**VILLAGE BOARD AGENDA
MONDAY, APRIL 27, 2015
7:00 PM
BOARD ROOM, MUNICIPAL BUILDING, 210 COTTONWOOD AVENUE**

MEMORANDUM

Aaron/John,
Village Staff met this morning to review Plan Commission agenda items for 4/20.

Village staff met this morning to review the Hartland Service Center plan submittal in preparation for the 4/20 Plan Commission meeting.

Date: 04.18.14
Sheet Title: PAVING PLAN
Sheet Number: C-104
Project Number: 4366
Drawn By: PEG
P11032

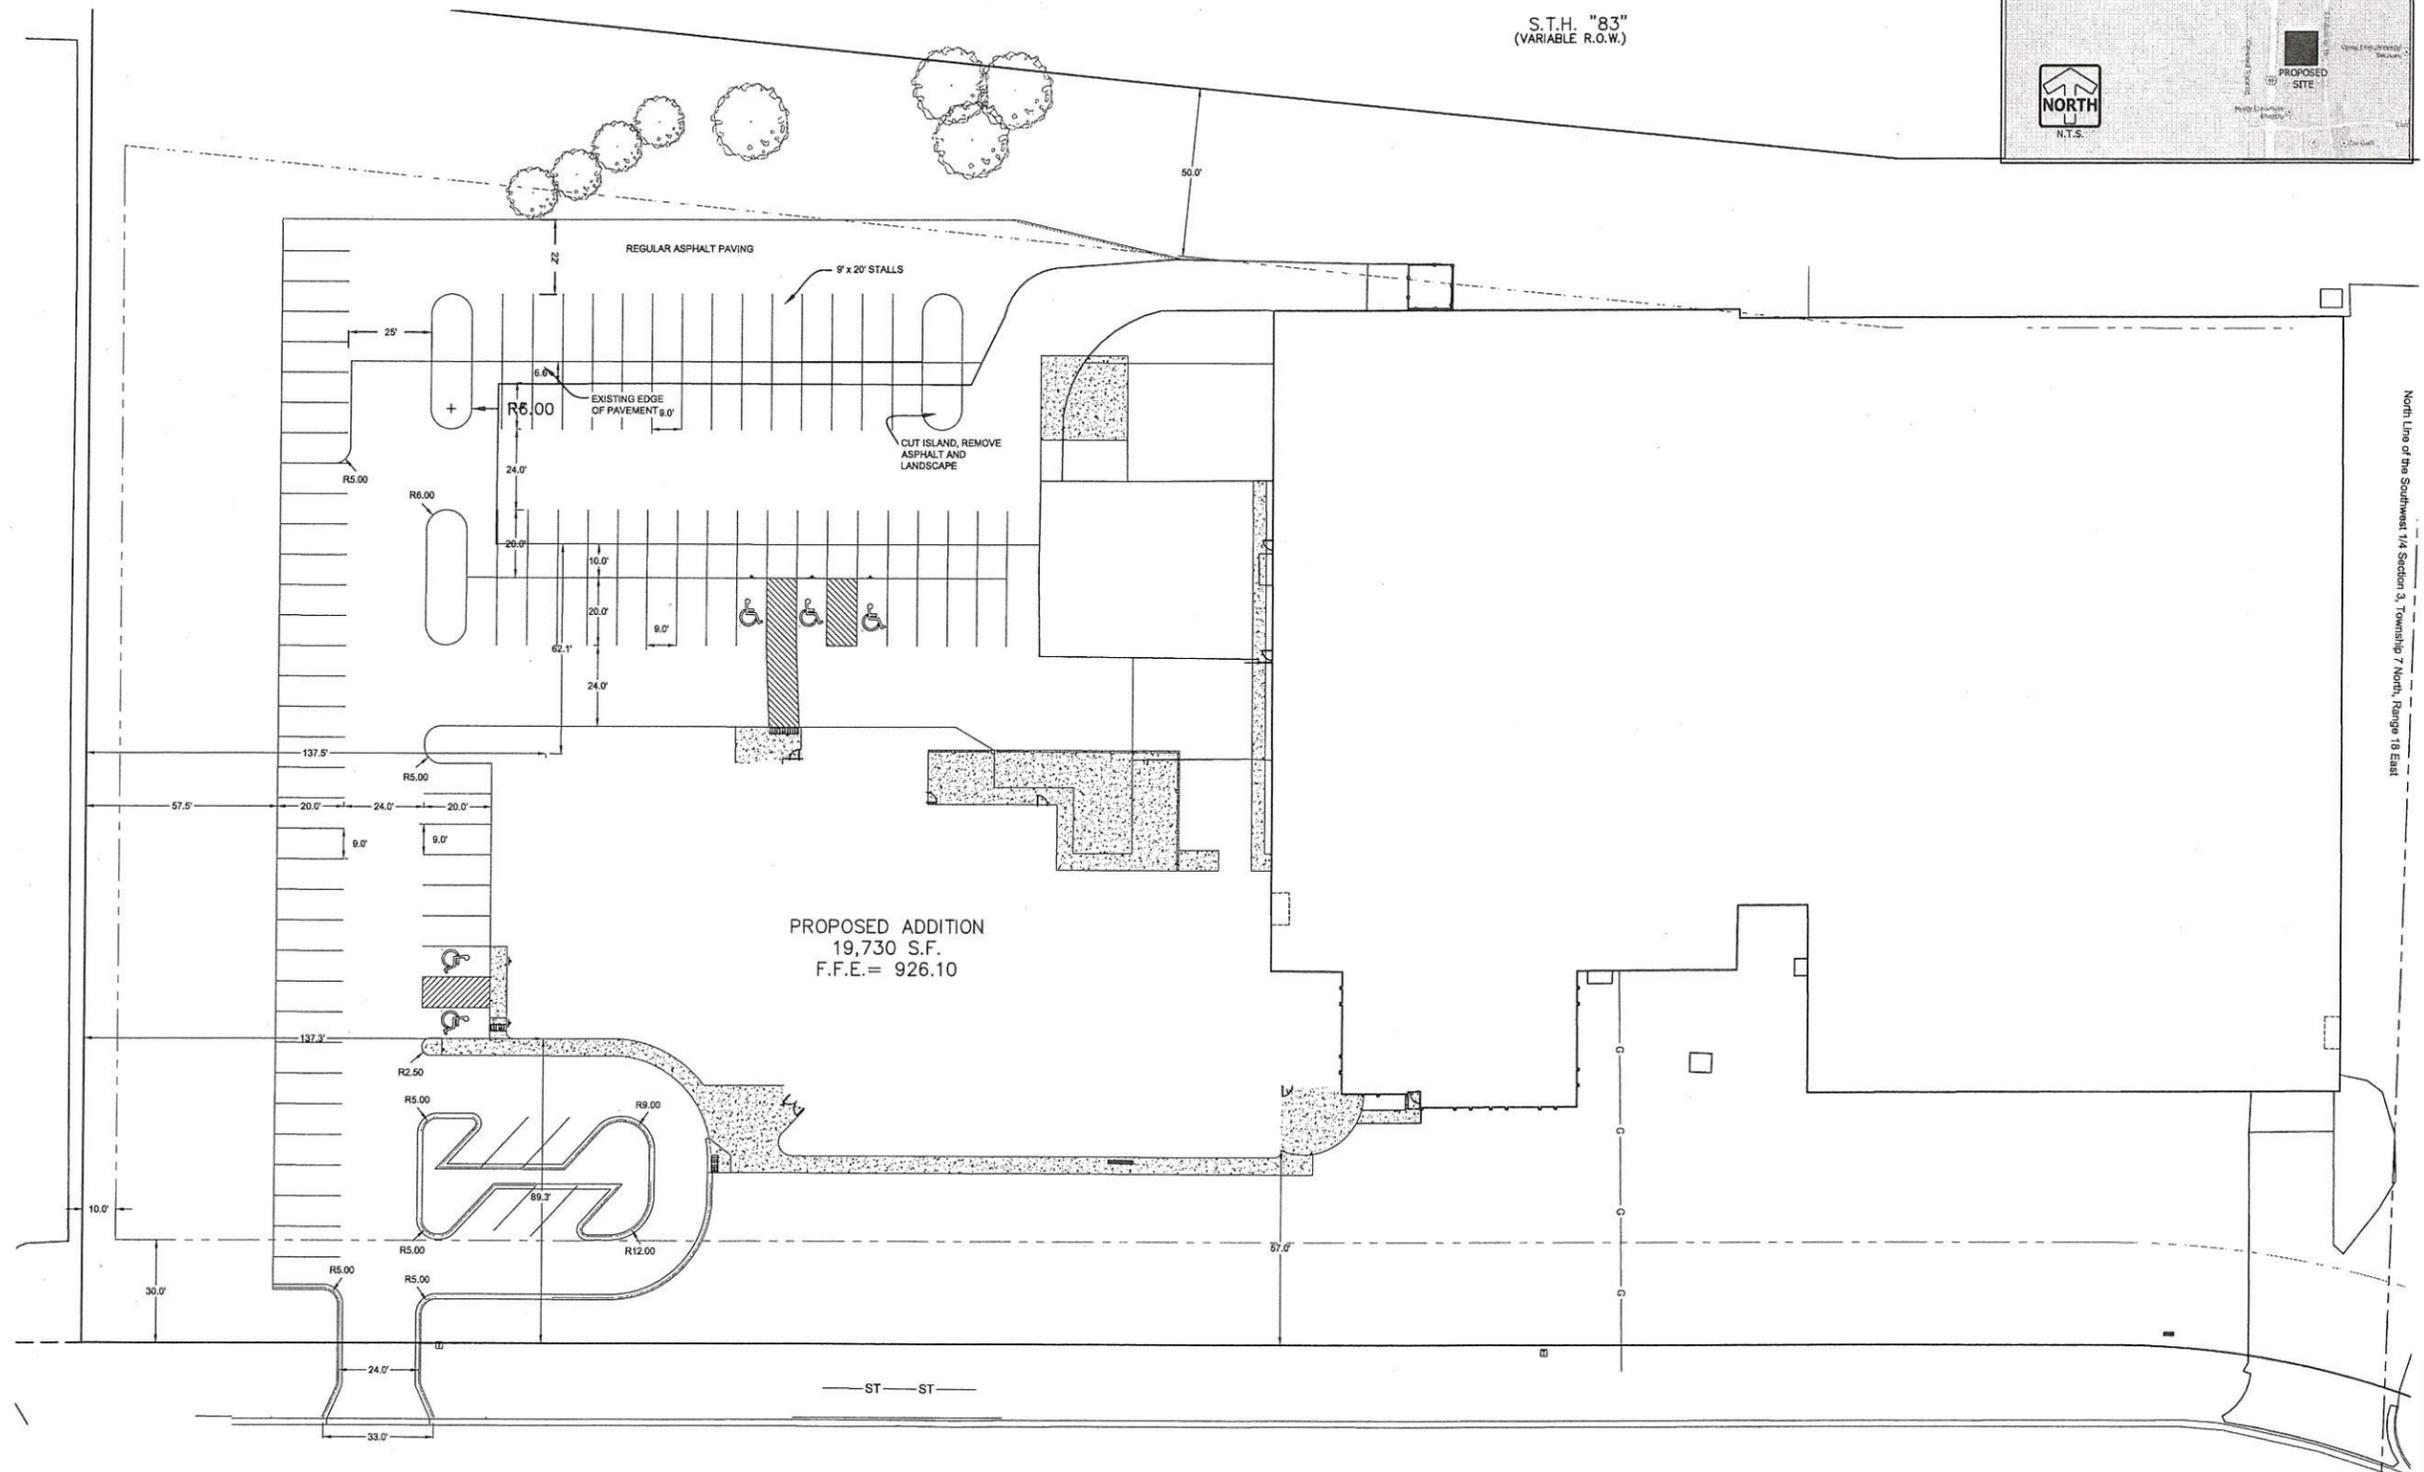
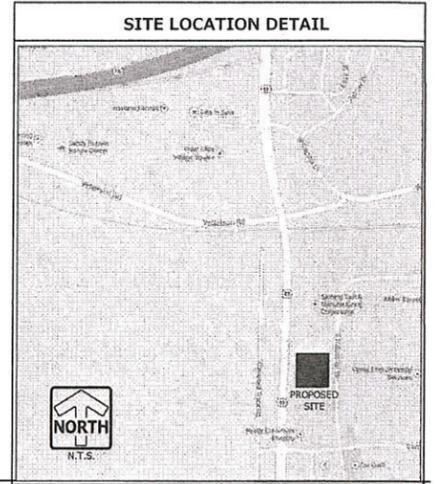
Partial buildout ... The one plan sheet showing a full buildout was submitted in error and I discussed this with Mike and Scott when I resubmitted the correct C104 page. We are not removing trees or installing a retaining wall

ORIGINAL LANDSCAPE PLANS

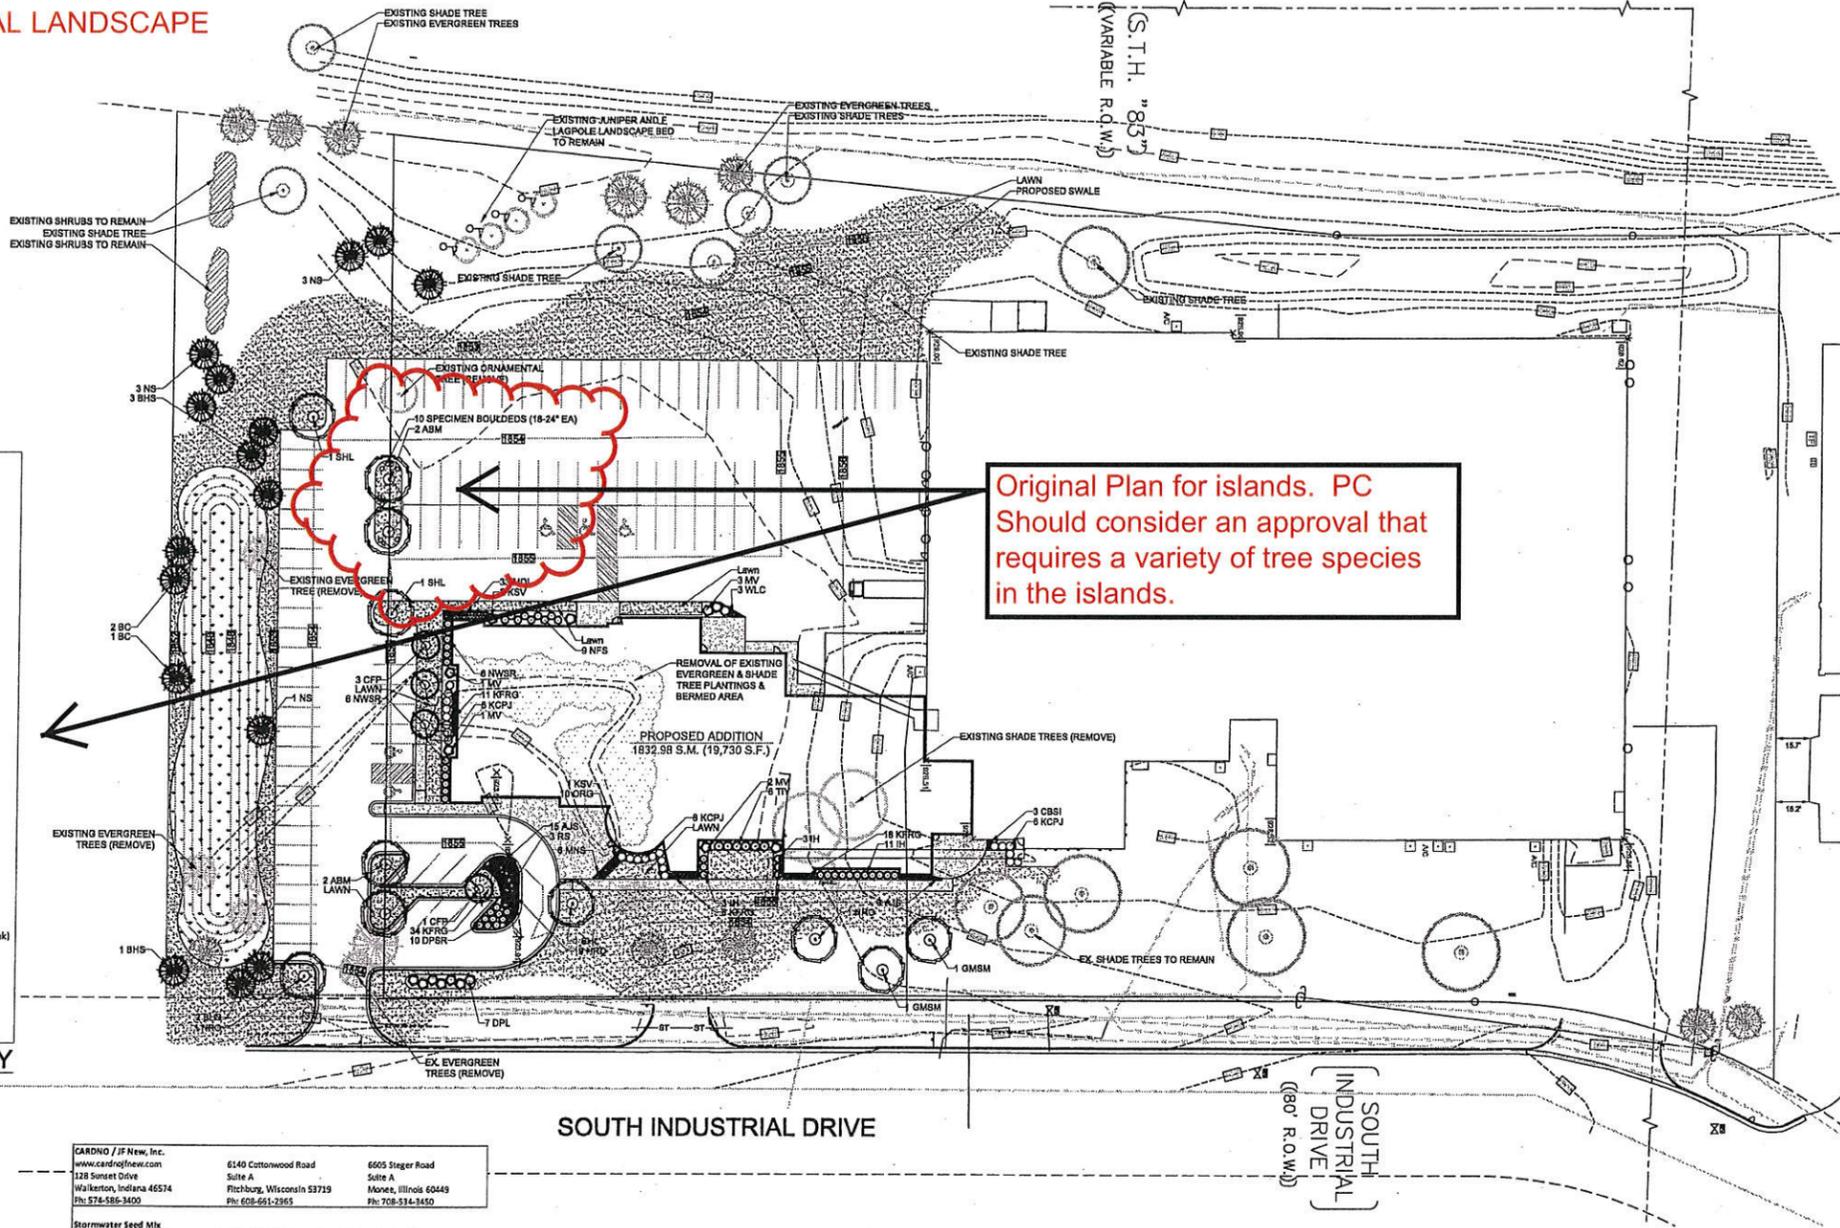
Original Plan for islands. PC Should consider an approval that requires a variety of tree species in the islands.

Yes, they will match the landscape plan for the original island

GRADING & EROSION CONTROL PLAN

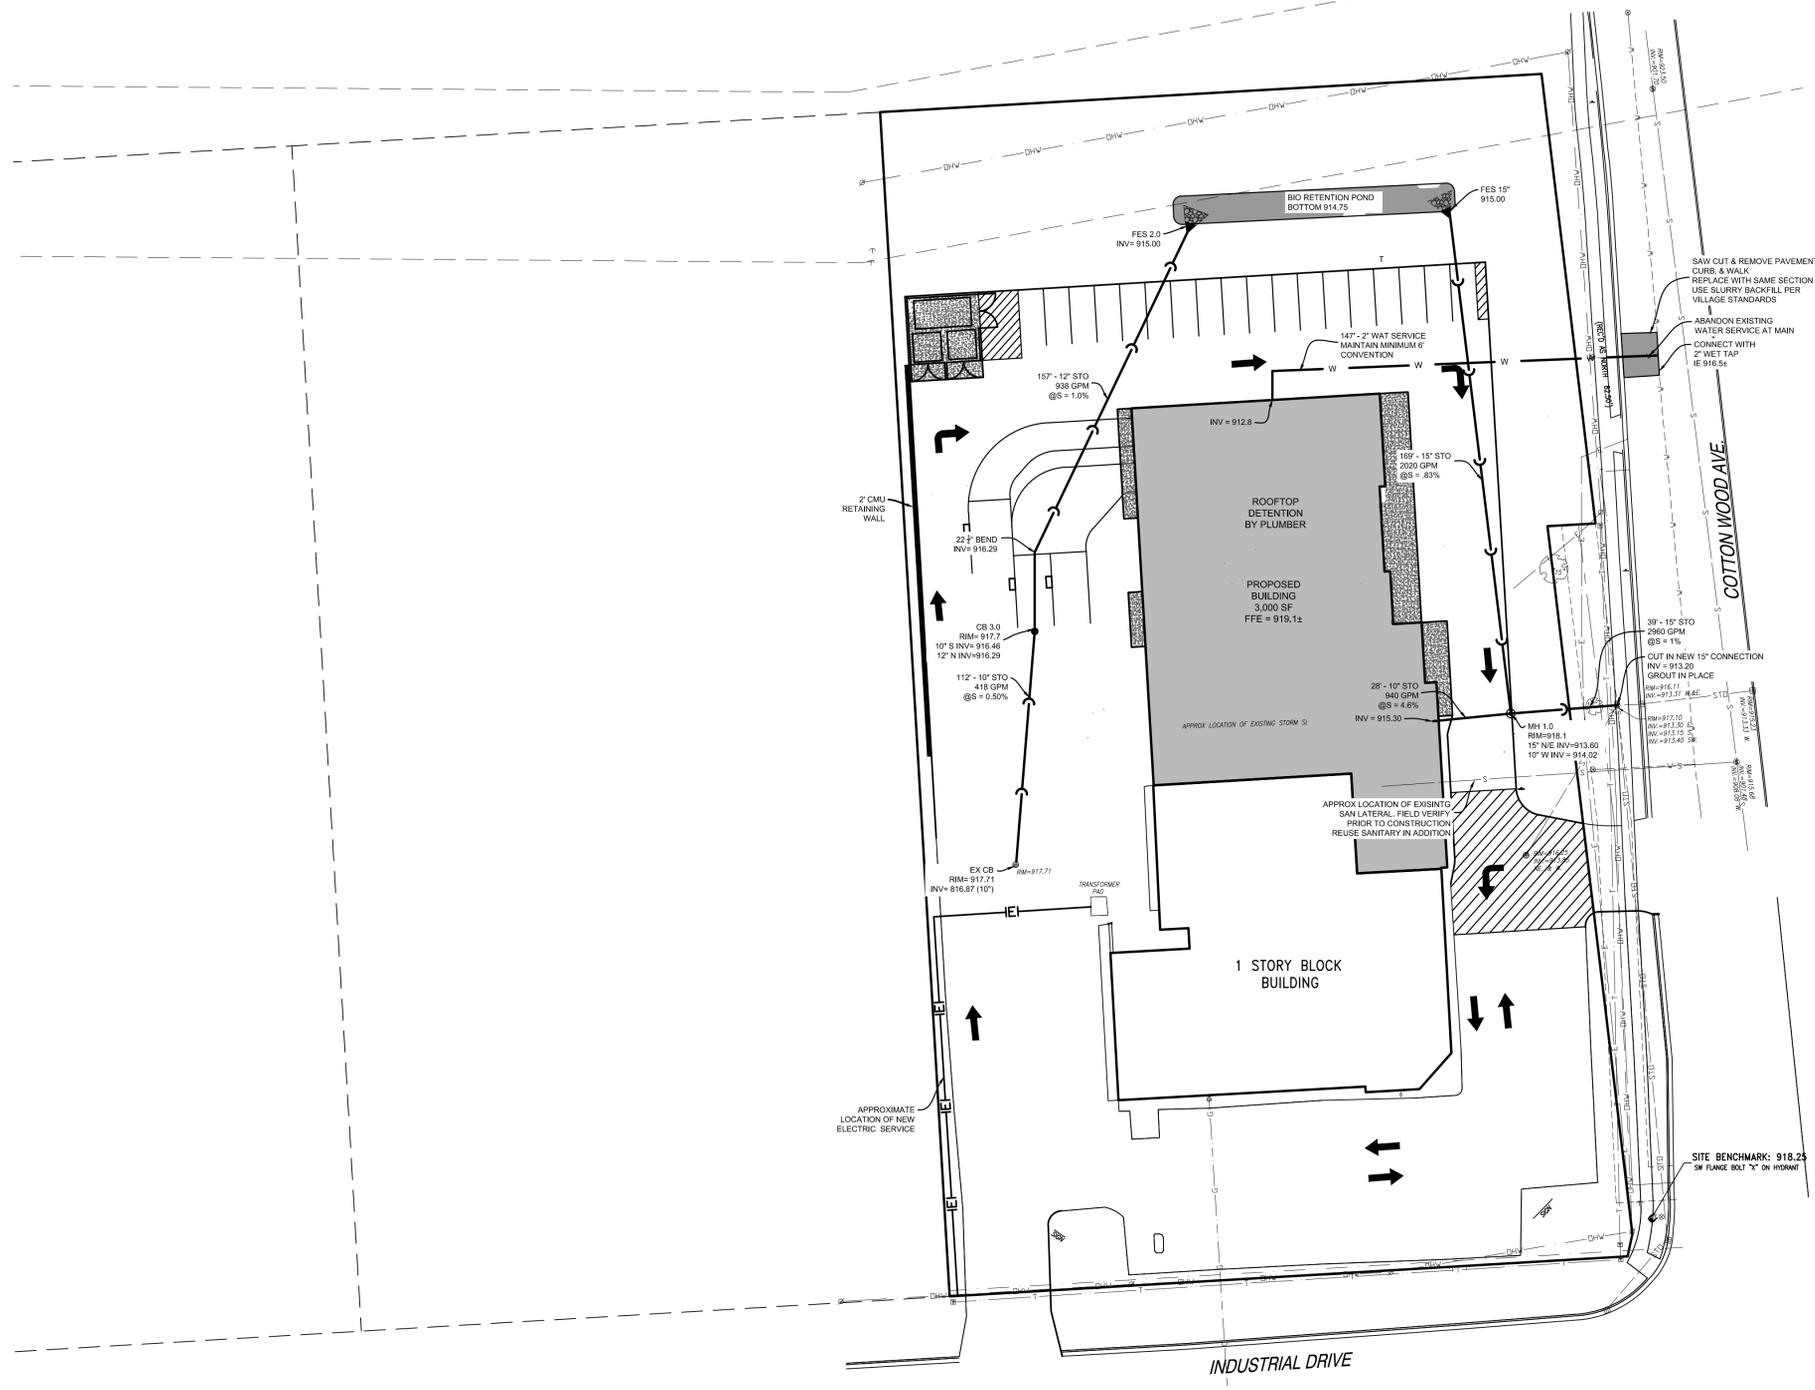
3. Show the removal of 2 driveway aprons along Cottonwood Avenue and provide details for the replacement with Village standard curb and gutter.
4. Sheet C-102, update reference to the construction sequence from Milwaukee/canal to Hartland.

We have adjusted our plans per the comments below. We would like to discuss further the request to not have construction access off of Cottonwood. The intention was to leave the current detail building in operation as long as possible on the northwest side. Should we have to bring all construction traffic in from Industrial only from the beginning this would mean a loss of that portion of business for Mike Kusch for the duration of the project. We would like to discuss that particular request further to see if a better solution that satisfies the Village and allows the detail service building to remain operational can be found.
